# Access Compliance Report

## Public Rights-of-Way

Intersection ID: 3448 Main Street: W W T HARRIS BV TO I-77 RA SB Street: I-77 TO W W T HARRIS BV RA SB Location: NE

ADA ID: E0FF296013D6 Ramp Type: Para Initial Pass/Fail: Fail Overall Compliance: No Severity Score: 12.5

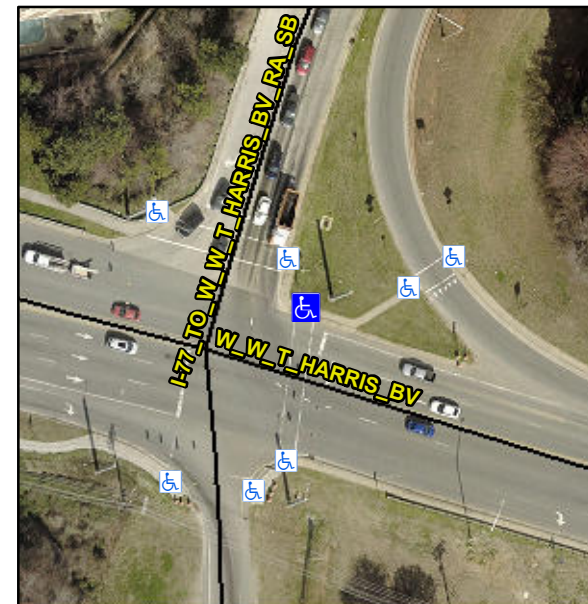
**R304.3.2**

Compliance	Description	Data	Compliance	Description	Data
N/A	Ramp Length LT (in)	72.0	N/A	Ramp Length RT (in)	72.0
Yes	Ramp Width LT (in)	60.0	Yes	Ramp Width RT (in)	60.0
Yes	Ramp Slope LT (%)	7.8	No	Ramp Slope RT (%)	9.2
Yes	Ramp XSlope LT (%)	1.2	Yes	Ramp XSlope RT (%)	0.9
N/A	Landing Length (in)	N/A	N/A	DWS Provided?	N/A
N/A	Landing Width (in)	N/A	N/A	DWS Contrast?	N/A
N/A	Landing Slope (%)	N/A	N/A	DWS Length (in)	N/A
N/A	Landing X Slope (%)	N/A	N/A	DWS Full Width?	N/A
N/A	Landing Curb? (Y/N)	N/A	N/A	DWS Offset (in)	N/A
N/A	Shared Landing?	N/A			
N/A	Gutter Ponding?	N/A	N/A	Gutter Slope (%)	N/A
N/A	Gutter Lip Ht (in)	N/A	N/A	Gutter X Slope (%)	N/A
N/A	Painted X Walk1?	Yes	N/A	Painted X Walk2?	N/A
	X Walk 1 Direction	To S		X Walk 2 Direction	N/A
N/A	X Walk 1 Width (in)	118.0	N/A	X Walk 2 Width (in)	N/A
	X Walk 1 Slope (%)	4.3		X Walk 2 Slope (%)	N/A
	X Walk 1 X Slope (%)	0.0		X Walk 2 X Slope (%)	N/A
N/A	Ramp inside XWalk1?	Yes	N/A	Ramp inside XWalk2?	N/A

**Remove & Replace Entire Ramp.**
